Ignition Distributor - Install Ventilation When Serviced

9403

March 29, 1994

Ignition Distributor Ventilation

Figure A

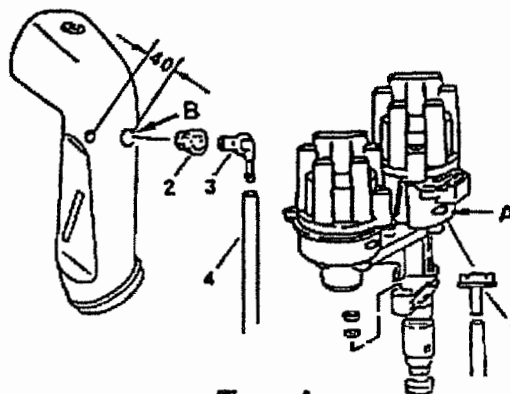
Ventilation for ignition distributor must be installed if replacement of ignition distributor becomes necessary.

If the ignition distributor requires replacement, on engines produced prior to the above engine numbers, a ventilation system must also be installed on replacement distributors which do not have it. After present stocks of new and rebuilt distributors are depleted only distributors with ventilation connection will be available.

- Use a screwdriver to remove the oval plate (arrow A) on the ignition distributor.
- Install ventilation connector (1) into distributor.
- Remove air guide pipe.
- Drill an 18 mm diameter hole (B) 40 mm to the right of the tail light ventilation into the air guide pipe.
